LORSON RANCH EAST FILING NO. 1

STREET, STORM SEWER, AND POND CONSTRUCTION PLANS

SHEET NUMBER
C0.1

DATE: MARCH 1, 2018
 PROJECT NO. 100.042
 SHEET NUMBER C6.25
 TOTAL SHEETS: 44

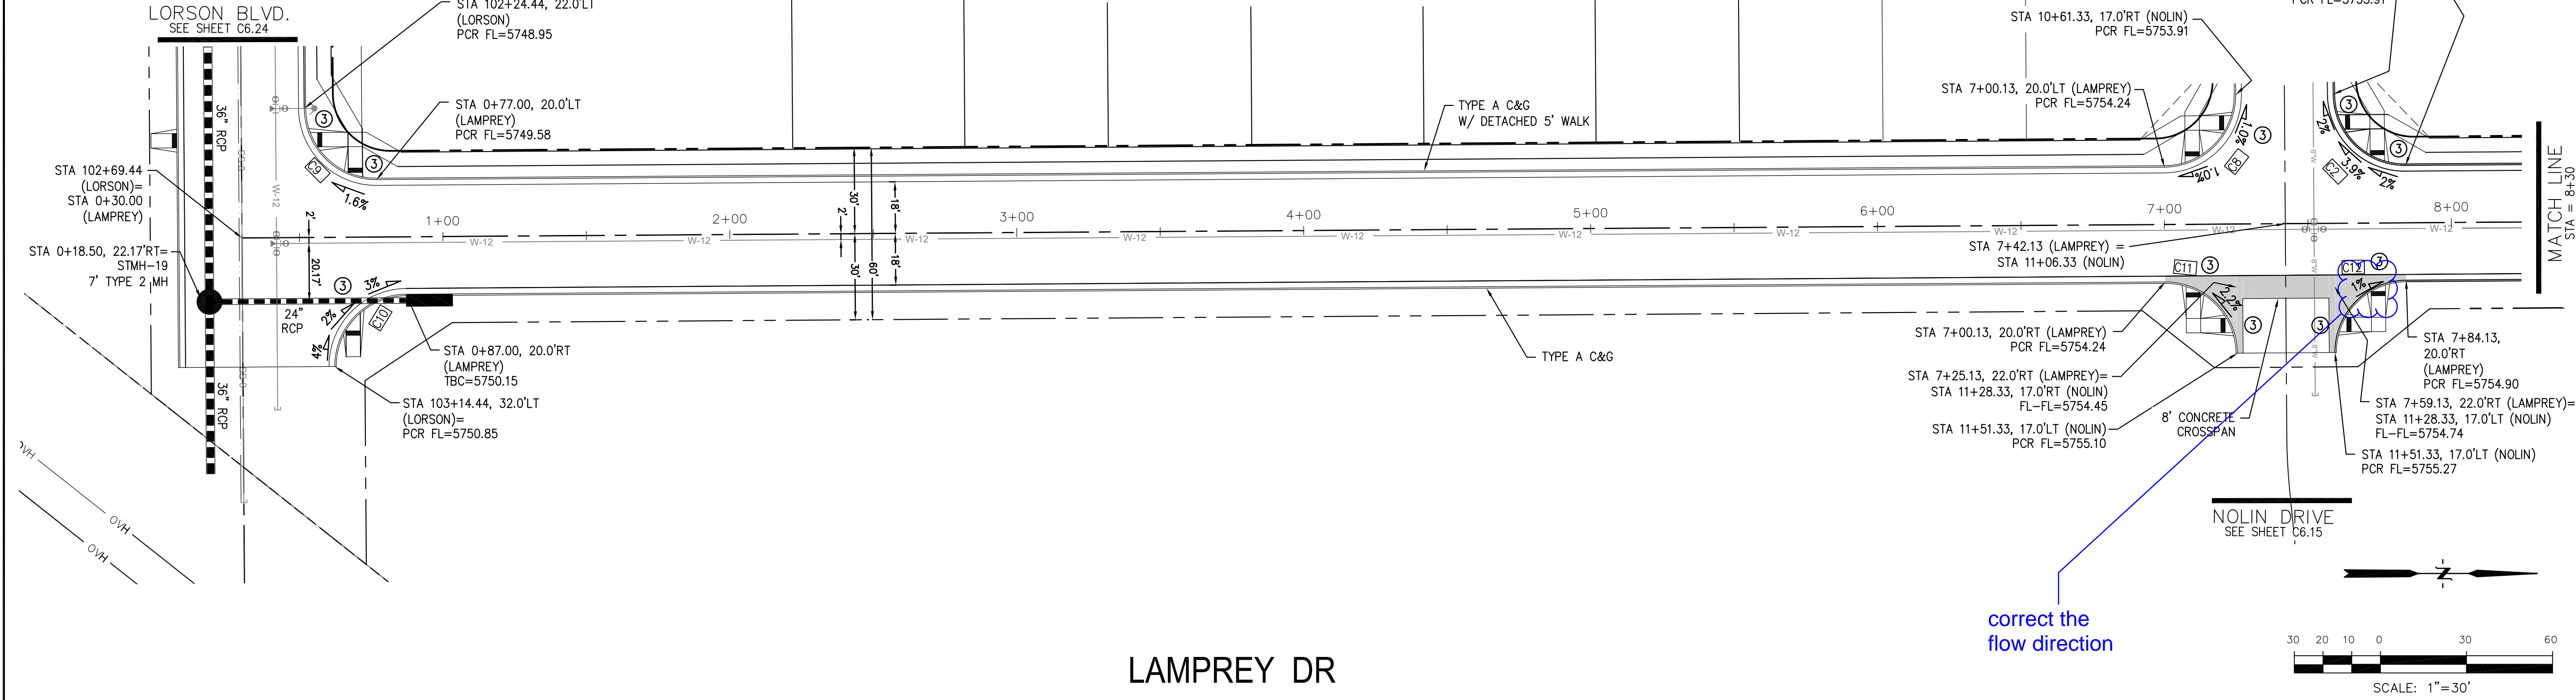
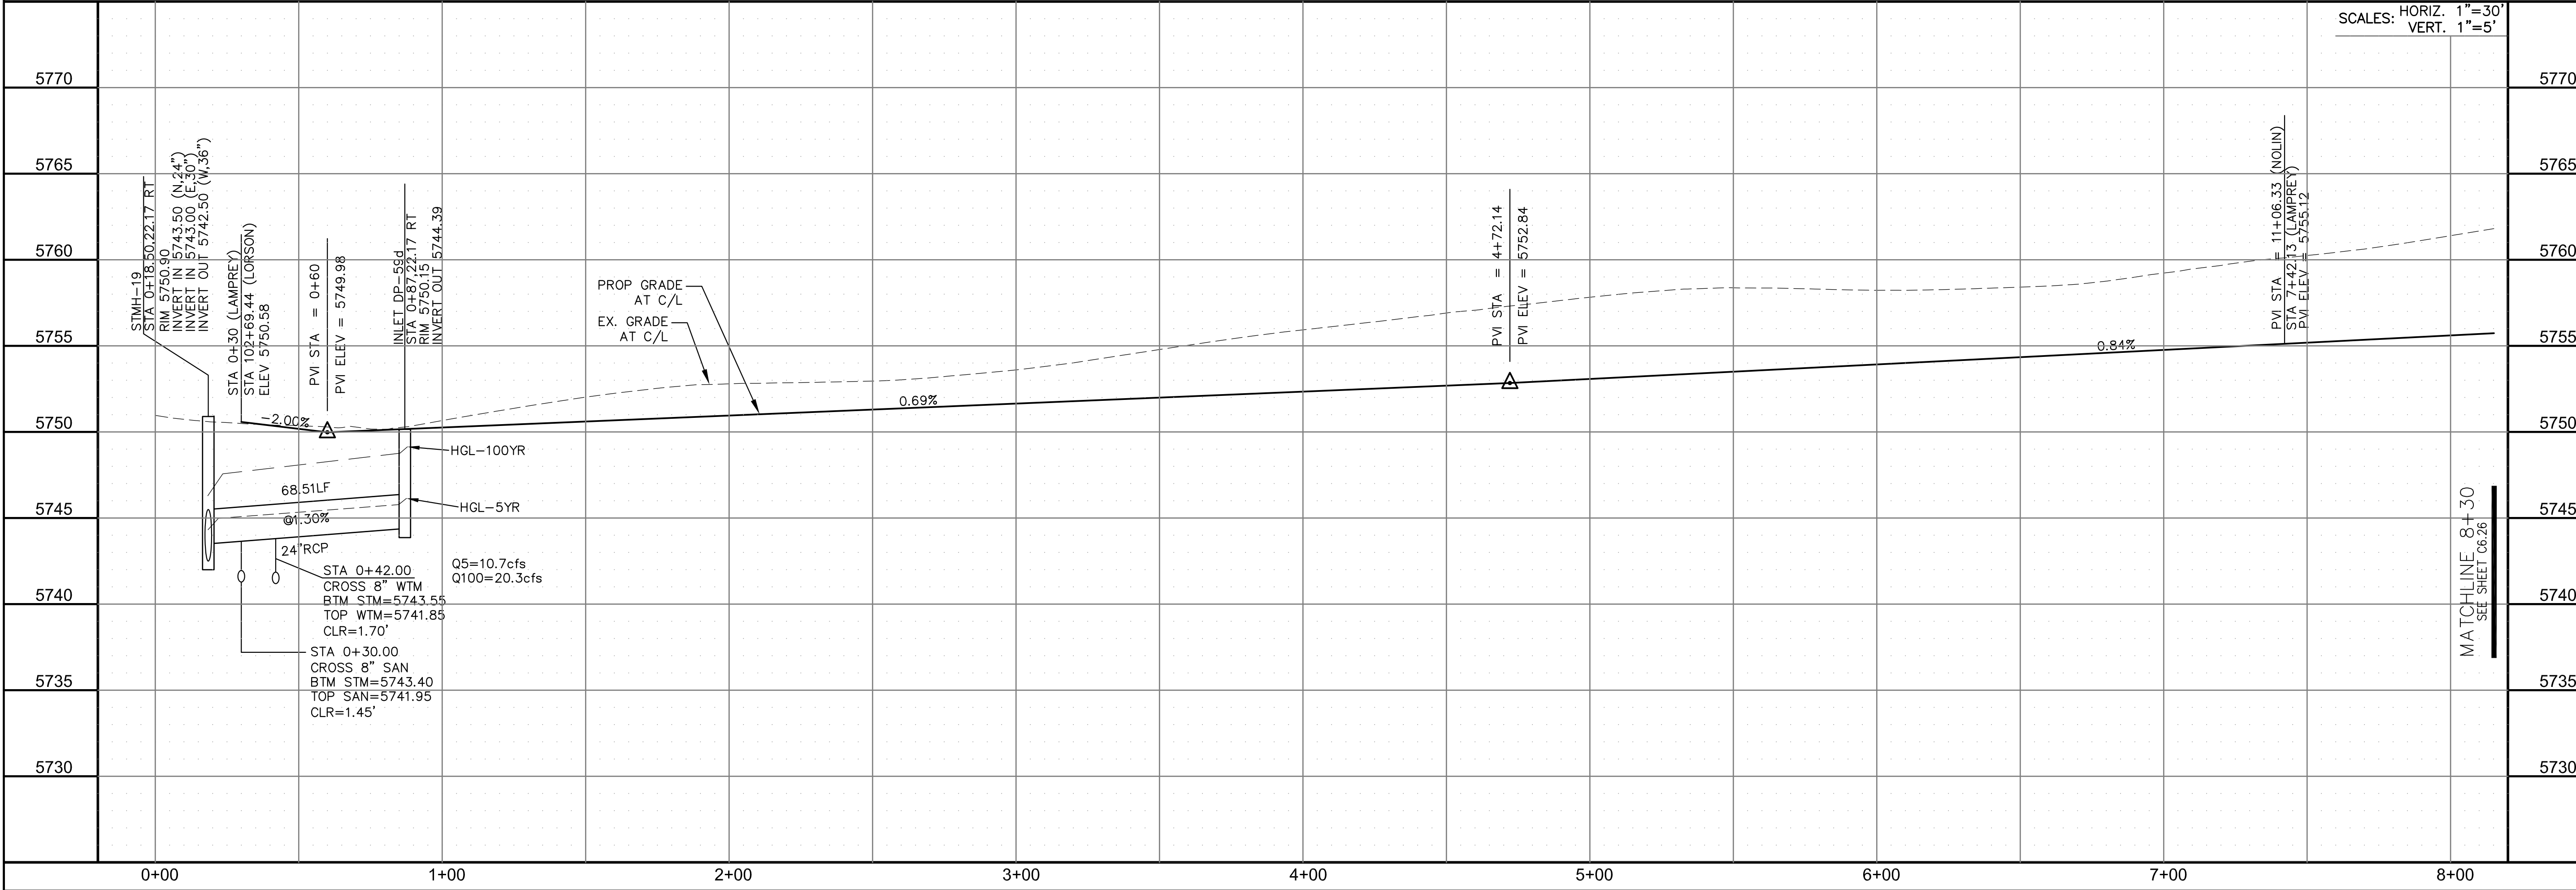
correct the flow direction

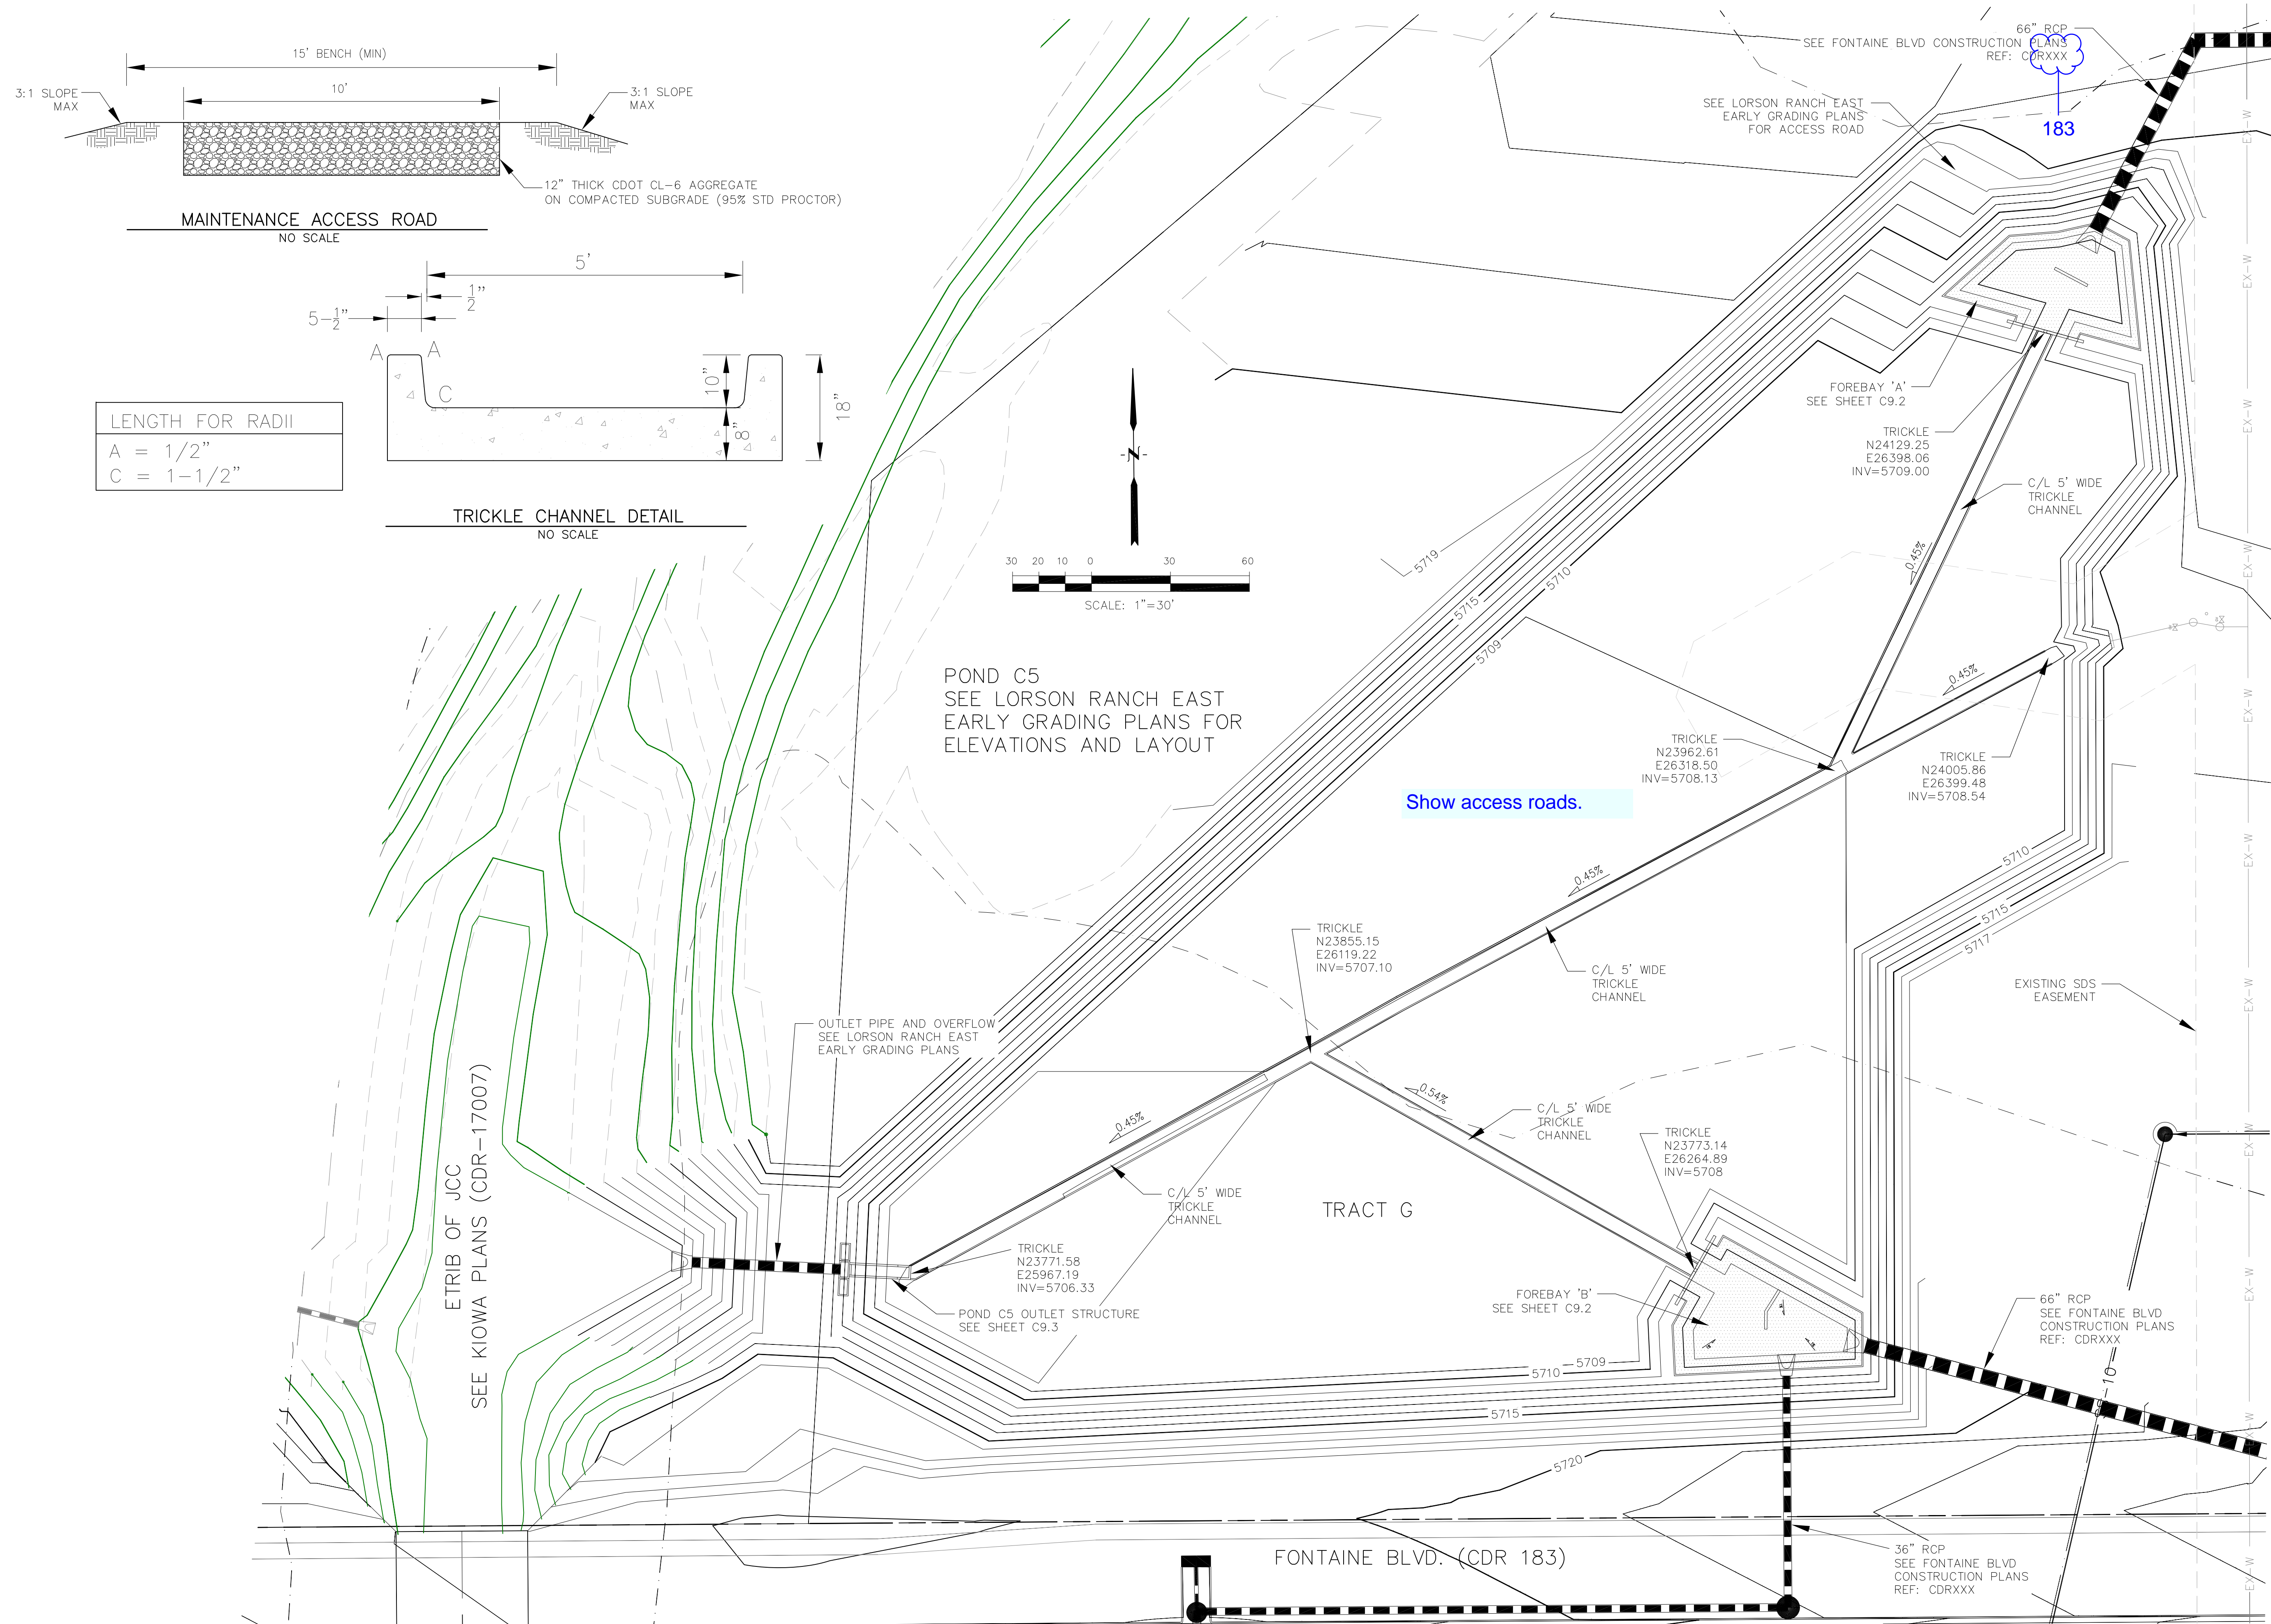
Show access roads.
